SYDNEY LIGHT RAIL EXTENSION STAGE 1 – INNER WEST EXTENSION Submissions Report

December 2010

Transport NSW

Figure 3.1 Indicative arrangement of the Dulwich Hill Interchange stop (alternative scheme 1)

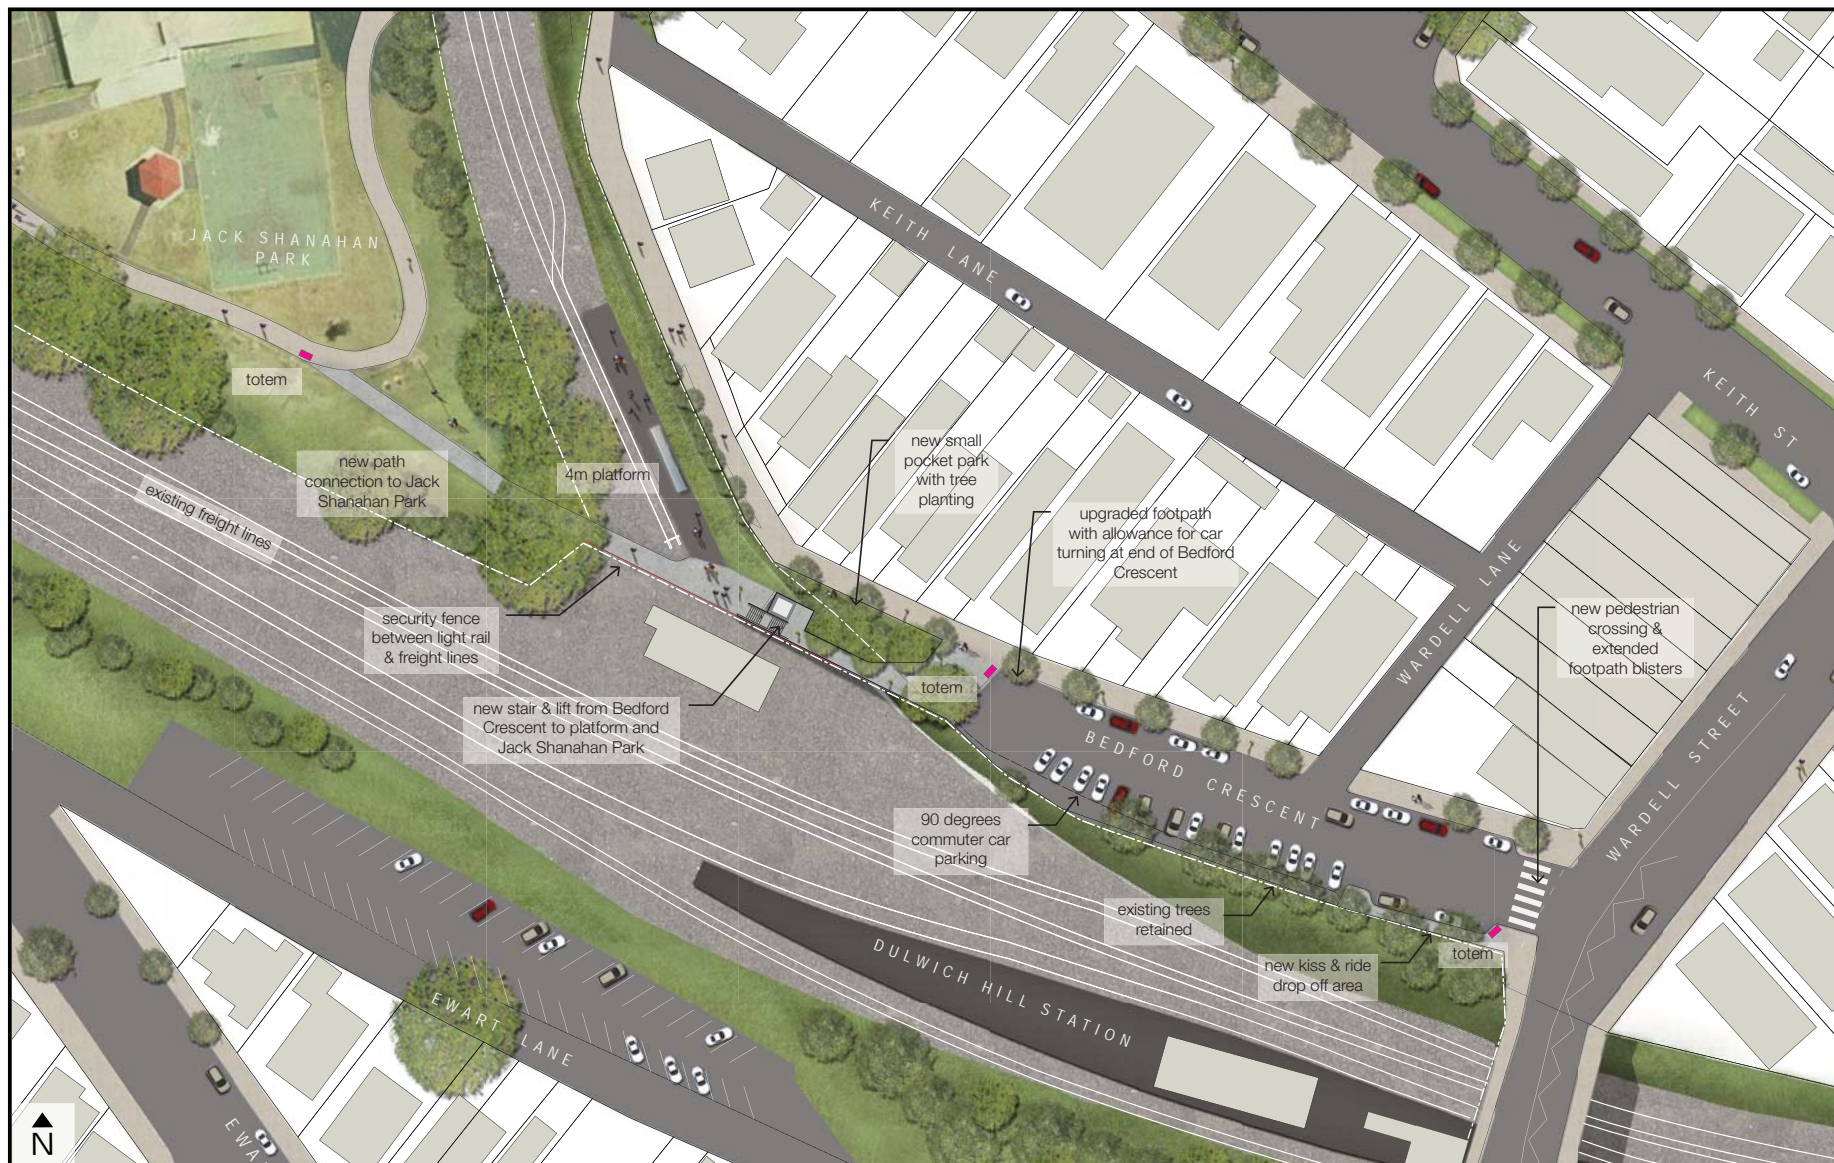
In the EA Transport NSW committed to carrying out further investigations and an options assessment process on this element of the project. These activities have been completed as detailed in Sections 3.2.1 and 3.4.1. As a result of the further investigations and options assessment process the location of the Dulwich Hill Interchange stop has been modified from that proposed in the EA. A description of the project design change is included in Chapter 6 of this report.

Alternative scheme 1a would locate the Dulwich Hill Interchange stop at the western end of Bedford Crescent between the existing residential properties to the east and Jack Shanahan Park to the west. An indicative arrangement of the Dulwich Hill Interchange stop alternative scheme 1a is shown on Figure 6.1.

A stair and lift from Bedford Crescent down to a new path would provide access to the stop platform and to Jack Shanahan Park. Alternative scheme 1a would provide improved neighbourhood connections across Jack Shanahan Park (see Figure 6.2).

Figure 3.3 Indicative arrangement of the alternative scheme for the Marion Street crossing

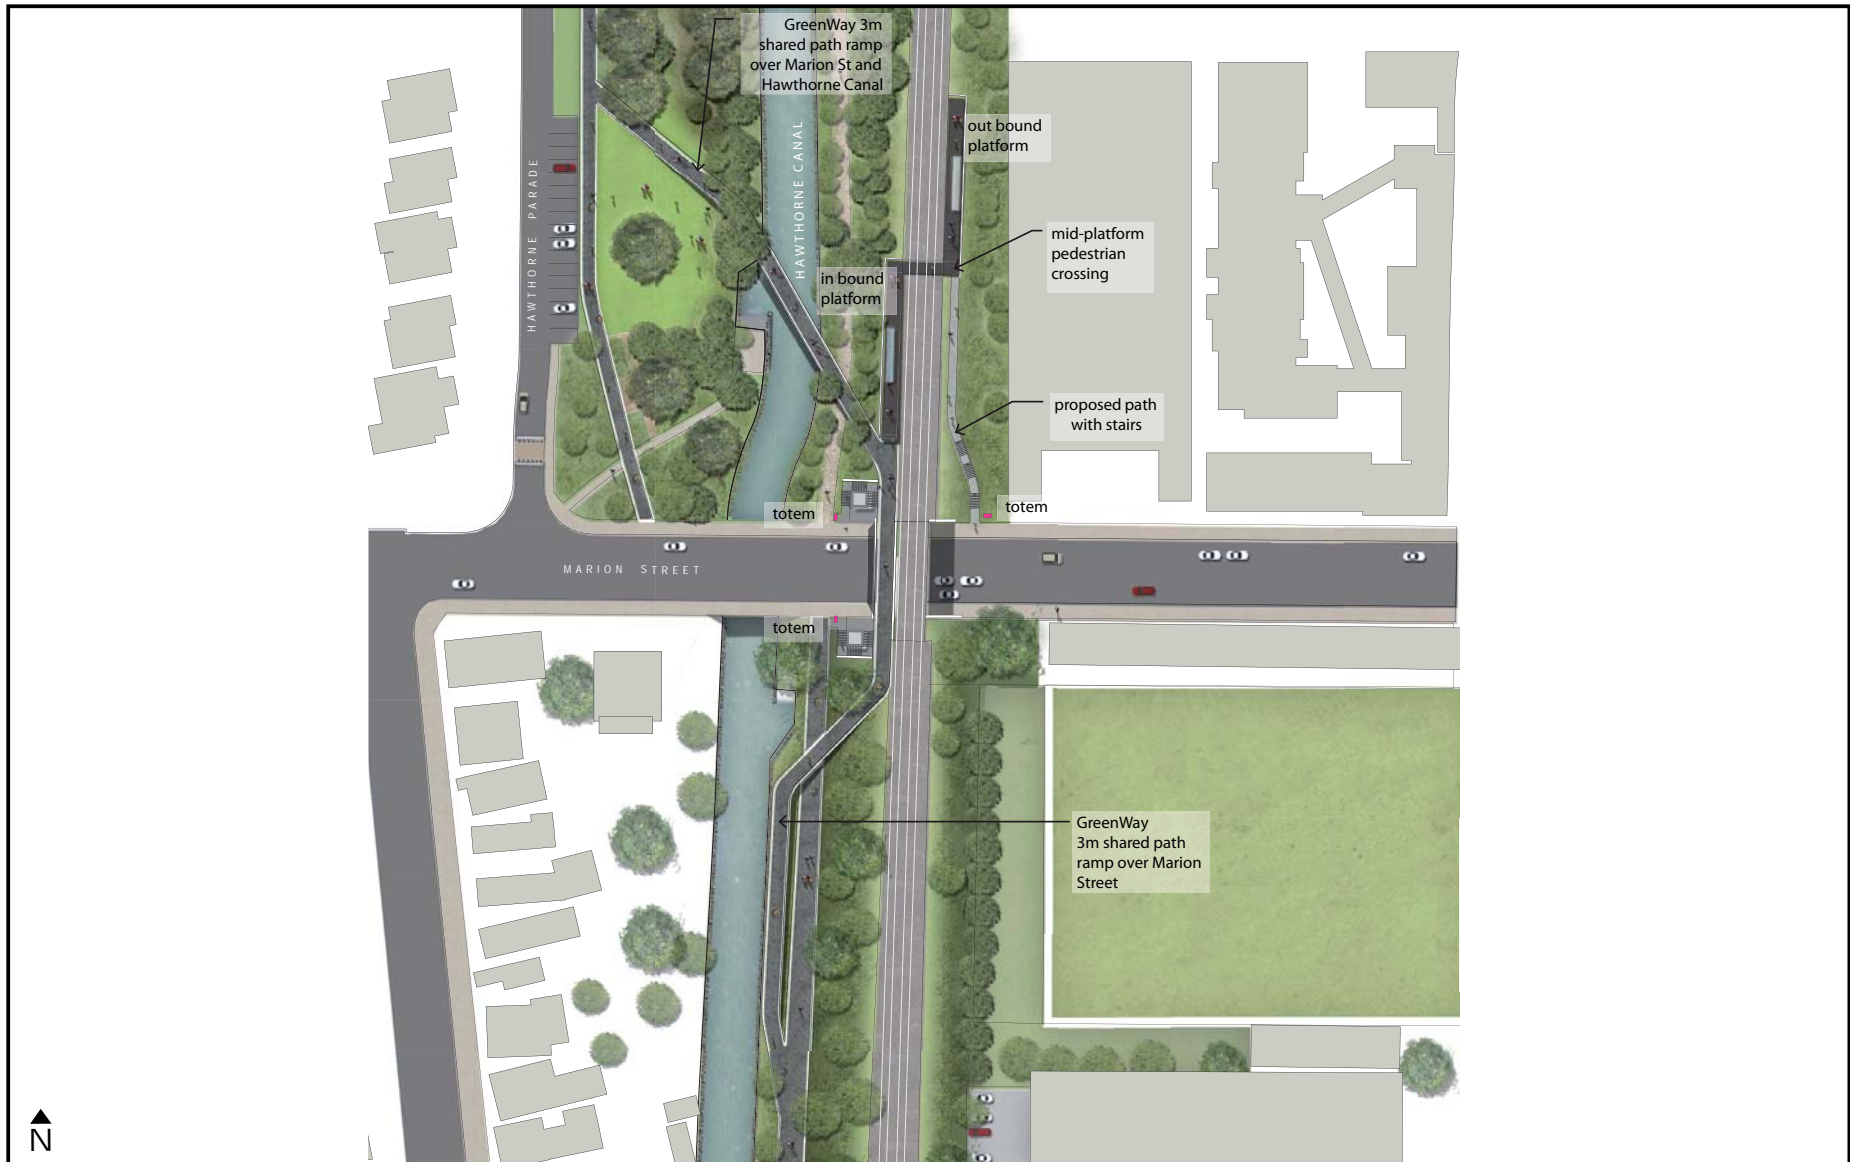
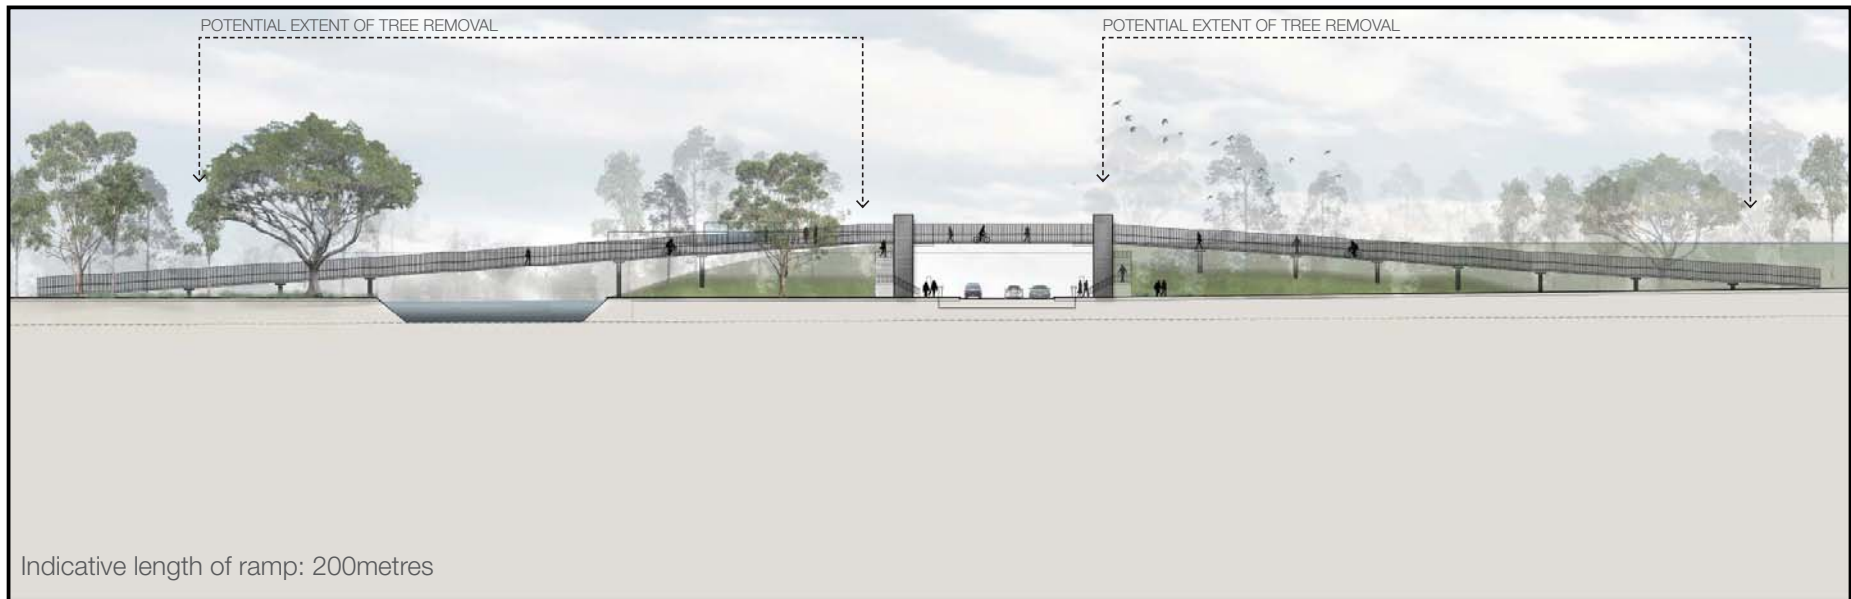
The RTA and Leichhardt Council have provided comment on the design and operation of the GreenWay shared path across Marion Street with the RTA's preferred option being a grade-separated facility. The issues regarding the crossing of Marion Street for pedestrians and cyclists have been addressed previously in Section 5.1.1. No change to the crossing of Marion Street, as presented in Chapter 6 of the EA, is proposed as part of the project. As part of detailed design, Transport NSW would consult with the RTA to decide on the most appropriate design and location of the at-grade signalised crossing.

In the EA, Transport NSW committed to carrying out further investigations and an options assessment process on this element of the project. These activities have been completed as detailed in Sections 3.2.2 and 3.4.2. As a result of the further investigations and options assessment process no change to the crossing of Marion Street, as presented in the EA, is proposed based on submissions received.

Figure 3.6 Indicative section of the GreenWay shared path at rear of Weston Street – alternative scheme 2
Note: Indicative only, subject to detail design.

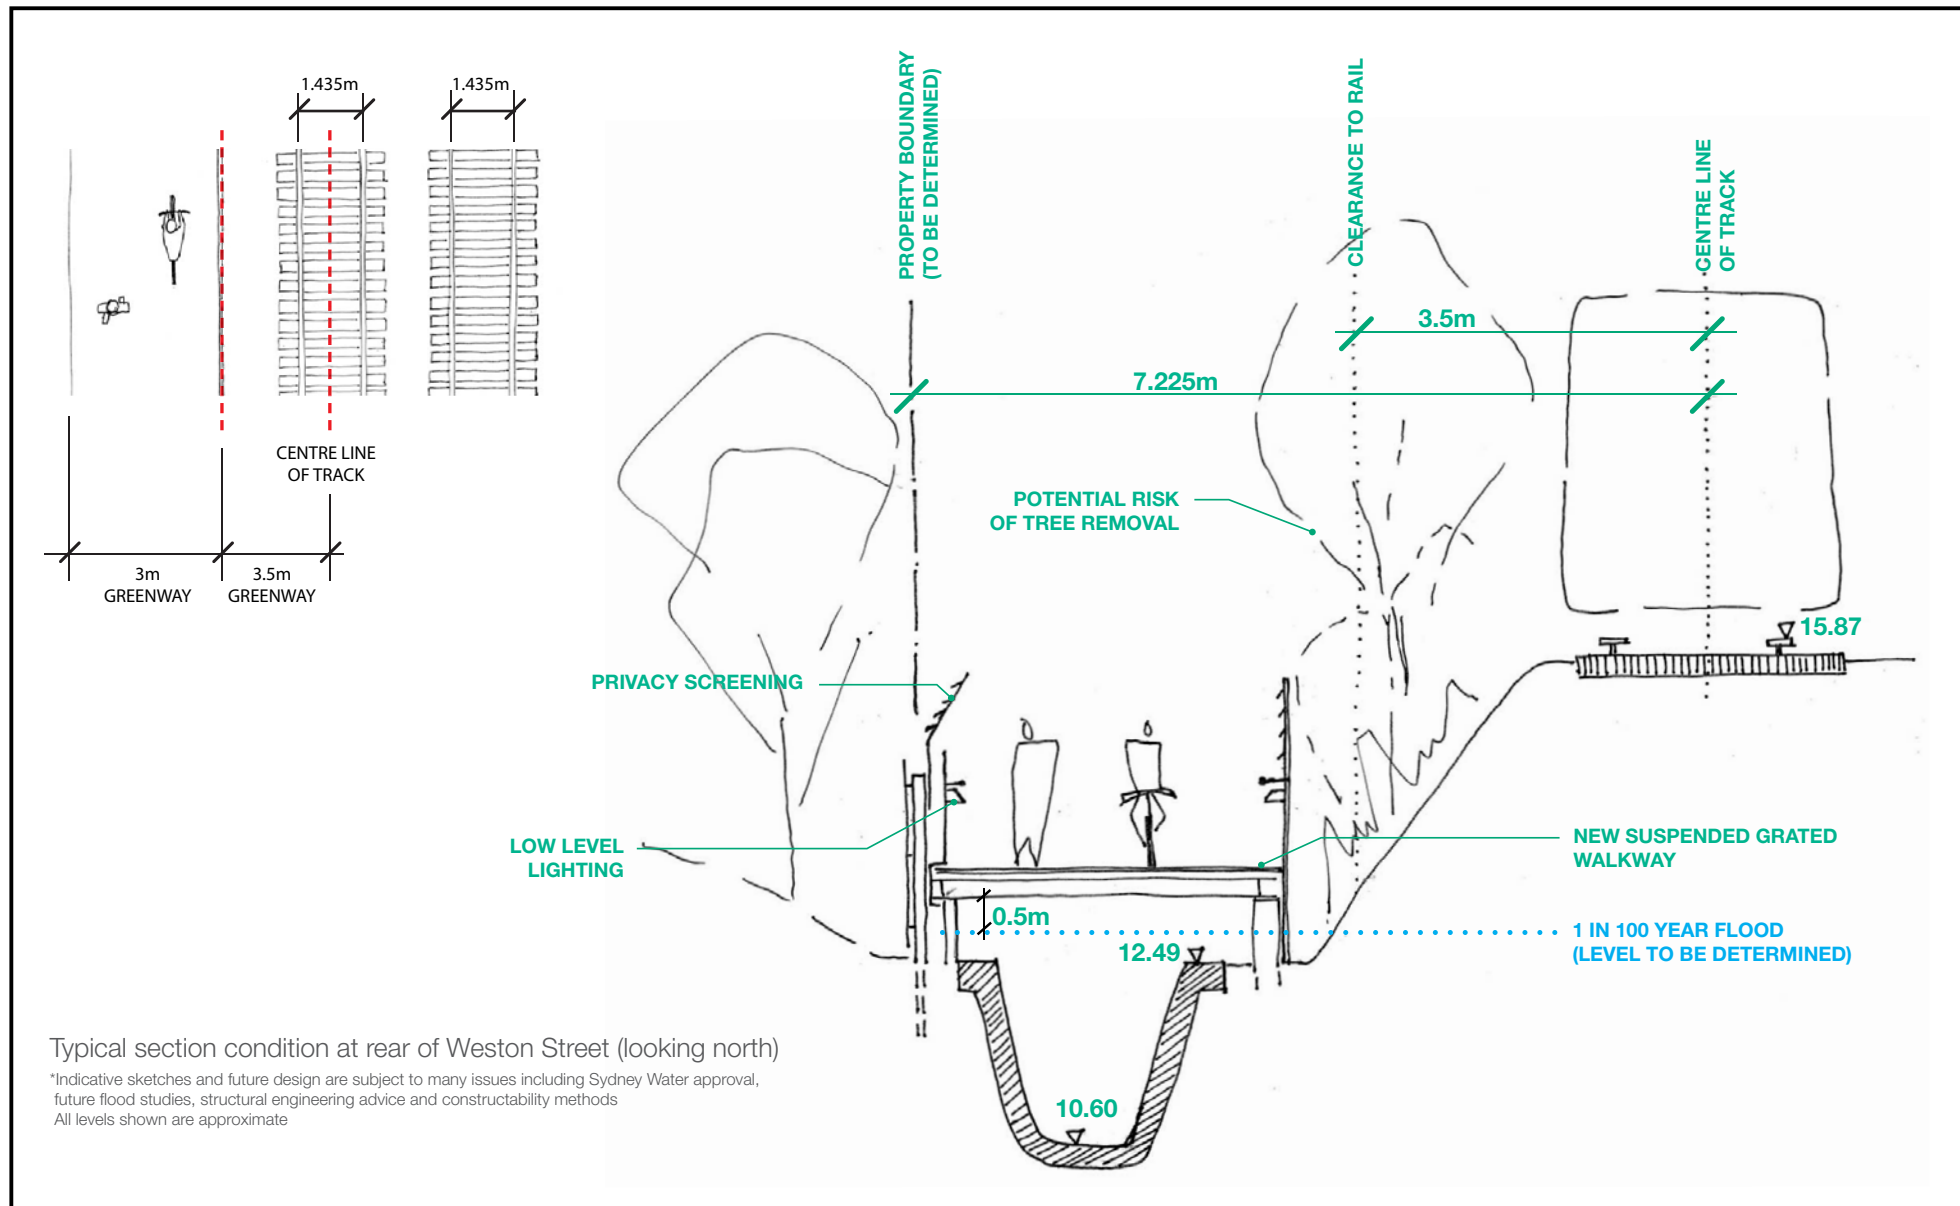
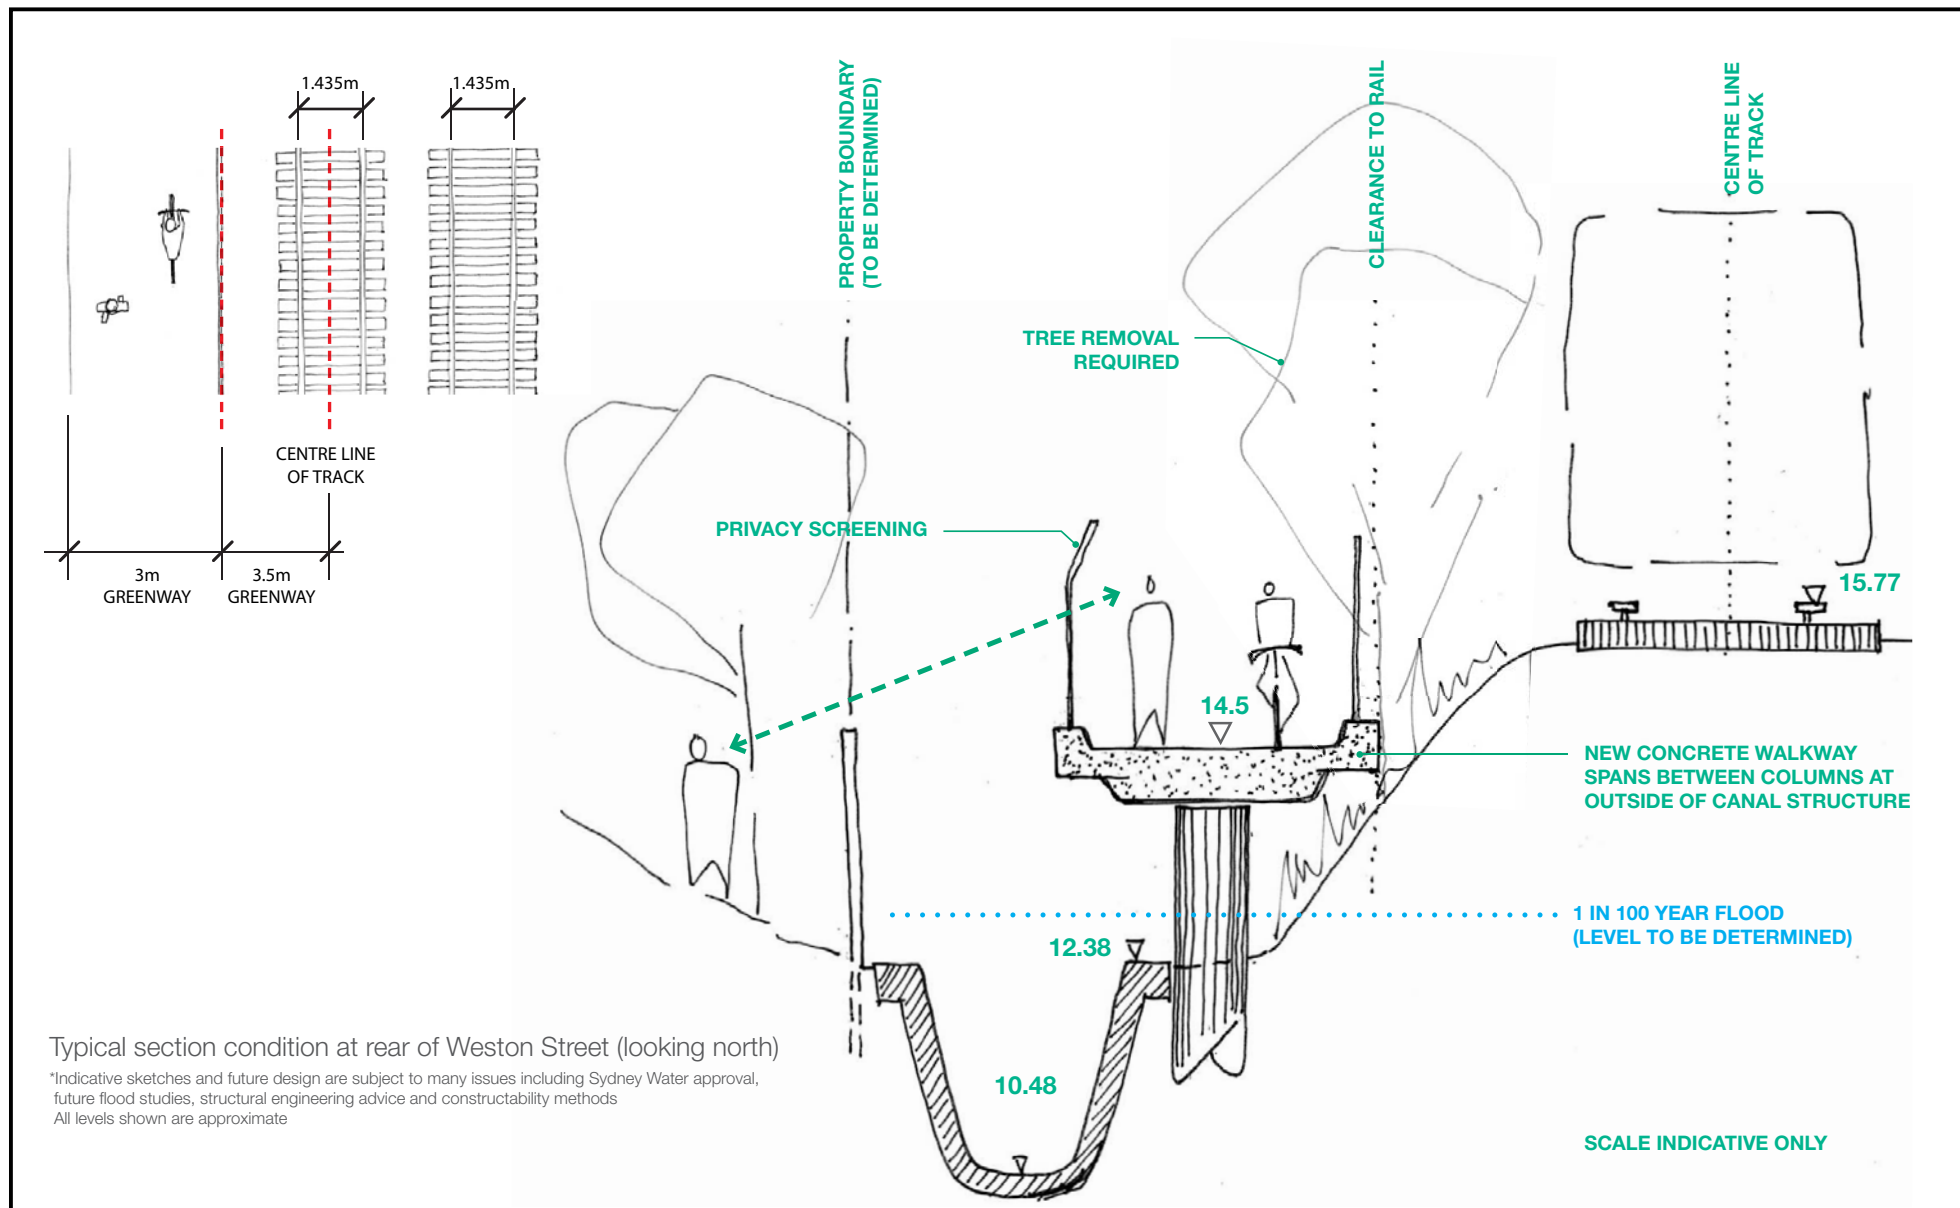
Issues relating to the location of the GreenWay on Weston Street between Davis Street and Old Canterbury Road were raised in 54 community submissions. Of these community submissions, 51 expressed support for the alternative schemes presented in the EA which would include the GreenWay in the rail corridor at the rear of the Weston Street properties and remove the GreenWay from travelling on-street on Weston Street (the base case scheme presented in the EA). The other two of the community submissions expressed support for the base case.

In the EA Transport NSW committed to carrying out further investigations and an options assessment process on this element of the project. These activities have been completed as detailed in Sections 3.2.3 and 3.4.3. As a result of the further investigations and options assessment process no change to the location of the GreenWay between Davis Street and Old Canterbury Road, as presented in the EA, is proposed based on submissions received.
